P99-020- I-80 Industrial Park- Raley Blvd. South of Main Ave.

- REQUEST: A. **Environmental Determination: Negative Declaration;**
- B. **Mitigation Monitoring Plan;**
- C. **Plan Review** to construct a warehouse totaling 132,408± square feet on 7.19± vacant acres in the Light Industrial- Review (M-1SR) zone.
- D. **Lot Line Merger** to combine three vacant parcels totaling 7.19± acres in the Light Industrial- Review (M-1SR) zone;

NOTICE OF DECISION AND FINDINGS OF FACT FOR

Exhibit 1B
Site Plan

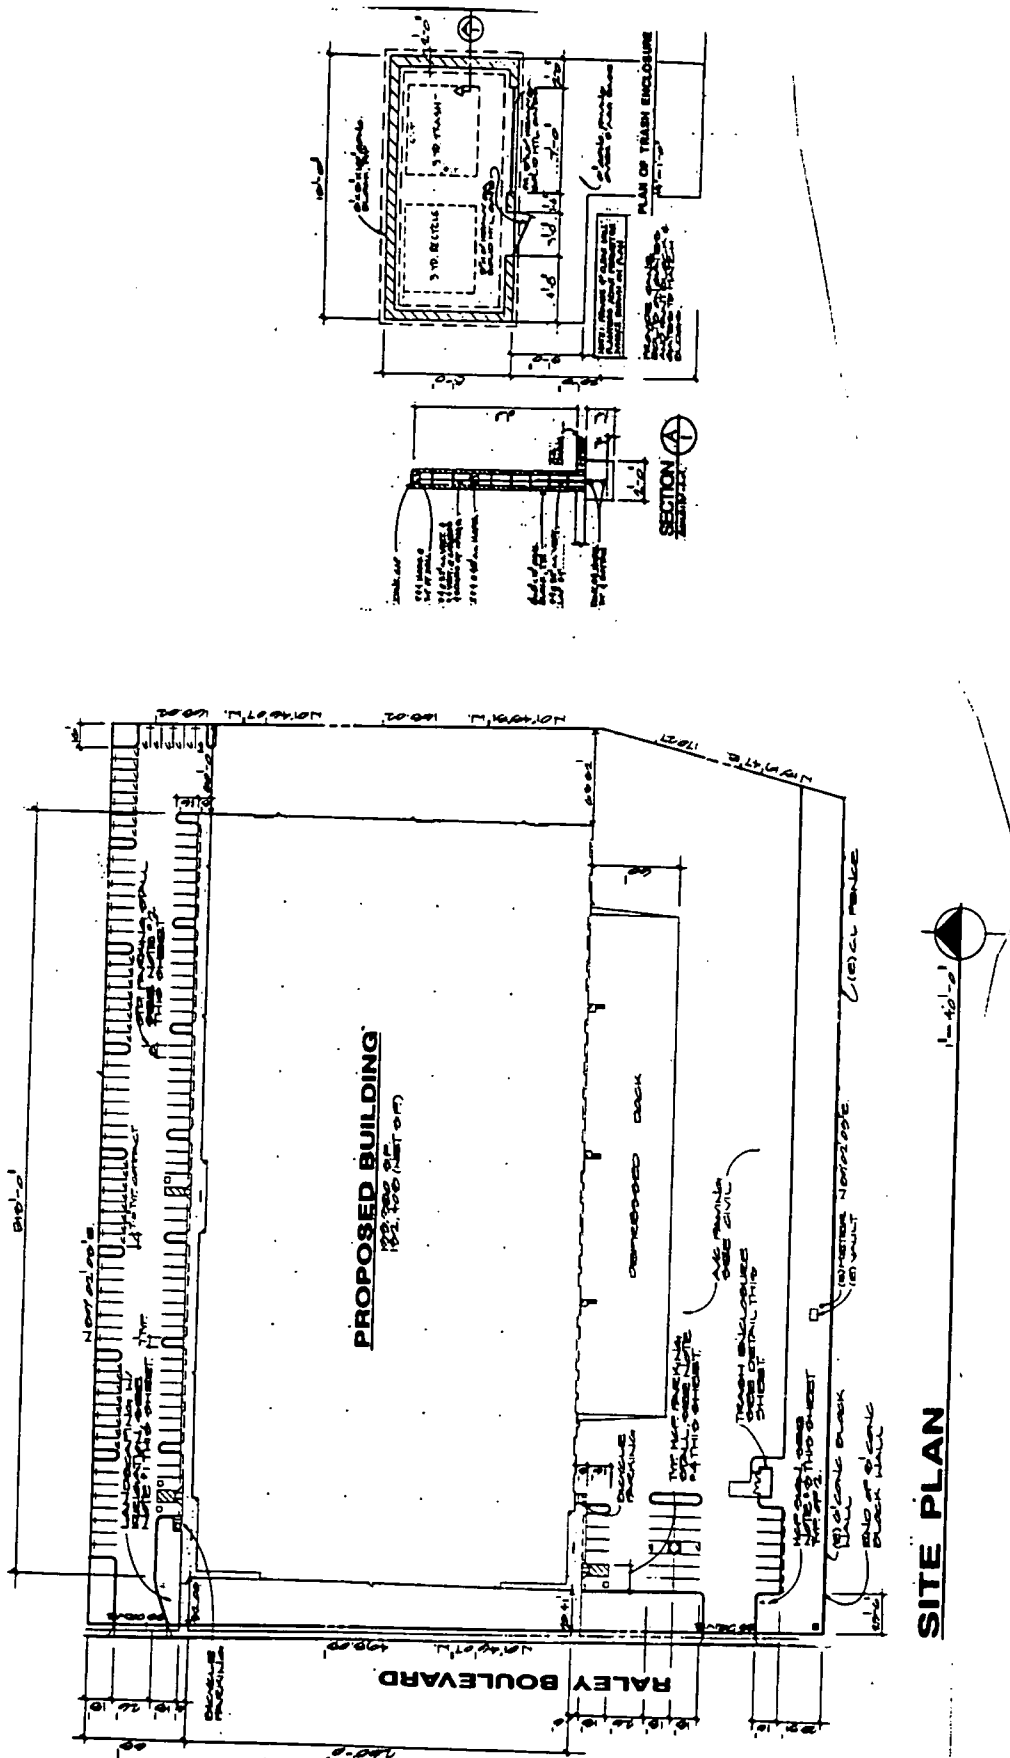
The Zoning Ordinance requires a six foot high masonry wall separating an industrial use from a residential use. The project plans show a masonry wall on the southern property line, but one is required along the northern property line which abuts a single family residence.

Comment: The applicant currently proposes 35' driveways. Since the use is industrial in nature the applicant is allowed 45' driveways per chapter 38 of City Code.

- C. Plan Review
- C1. Construct a masonry wall along the northern property line which abuts a single family residence.
 - C2. Construct a parapet on all four sides of the building.
 - C3. Provide standard subdivision improvements pursuant to Section 40.12.1211 of the City Code.
 - C4. Dedicate and construct Raley Boulevard to a 55' half-section to the satisfaction of the Department of Public Works (see attached graphic).
 - C5. The applicant shall construct the full median of Raley Boulevard from the existing median nose to the South of the subject site to the North property line of the subject site.
 - C6. The minimum throat depth for driveways on Raley Boulevard is 50 feet. Throat depth is measured from the right-of-way line, and is the distance into the site a vehicle can travel before being able to make a right or left turn.

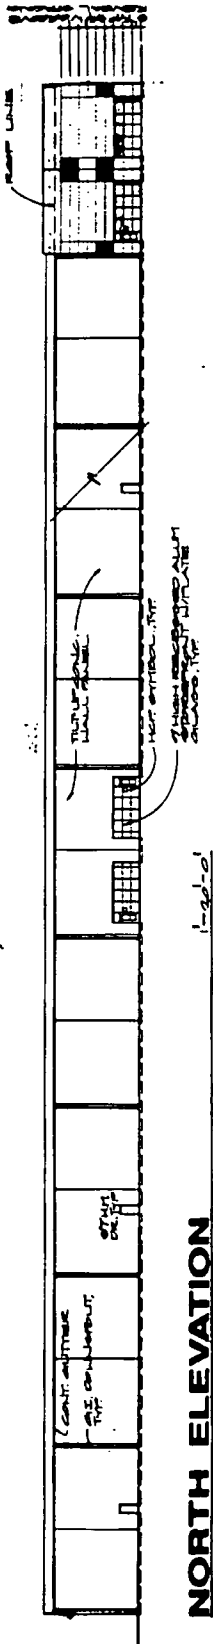
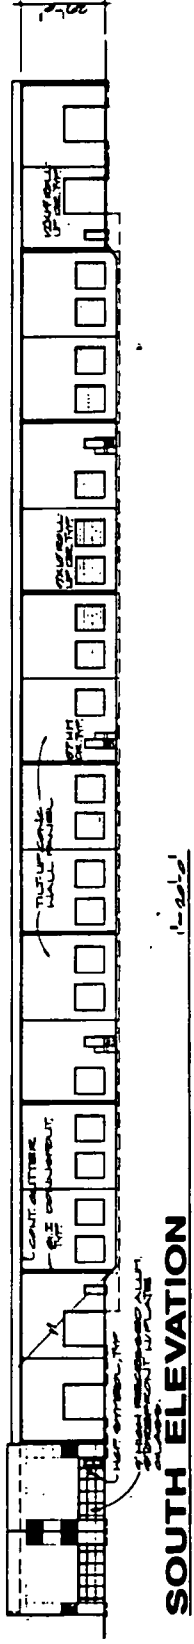
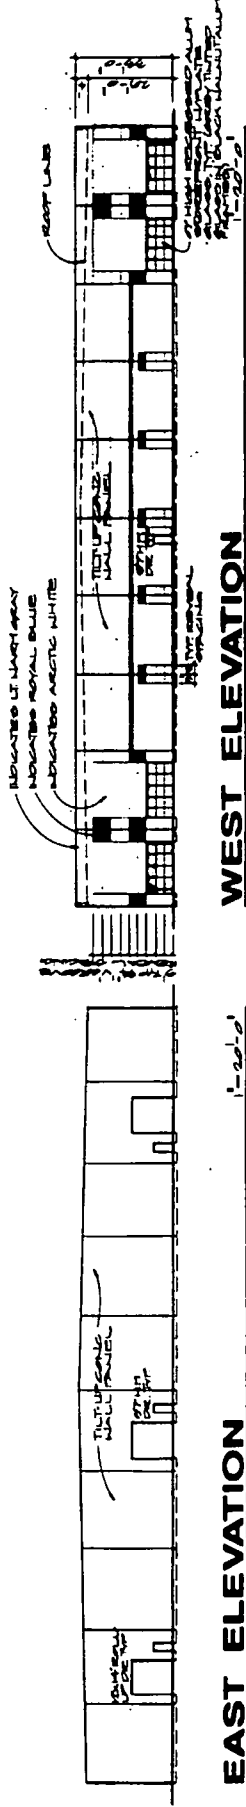
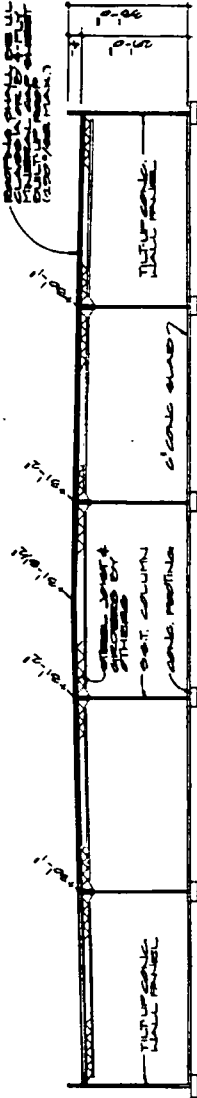
The proposed project would be a typically concrete tilt-up warehouse. The height of the proposed buildings would be 33± feet. The warehouse would be similar to the other warehouses in the surrounding area. The building plans show the parapet missing from the east side of the building. In order to hide the mechanical equipment on the roof, and to be in conformance with other warehouses built in the area, the building should have a parapet on all sides. The enhanced west elevation is a good addition to the warehouse. The color of the building walls would be a light warm gray walls, Royal blue accent panels, and arctic white panels above the plate glass windows on the western elevation. Staff has no issue with the design other than the issue with the missing parapet wall on the east elevation.

Issue: Parapet walls on four (4) elevations

| PROPOSERS Applicant | | |
|---------------------|-----------------------|----------|
| | ⊗ 504 a square foot | |
| | for a parapet wall | |
| | Approx: 50,000 | |
| | ⊗ Building under | |
| | construction was | |
| | partial parapet wall | |

| OPPONENTS CPC | | |
|---------------|----------------------|----------|
| Phil: | Send a strong signal | |
| | that we need good | |
| | designed warehouses | |
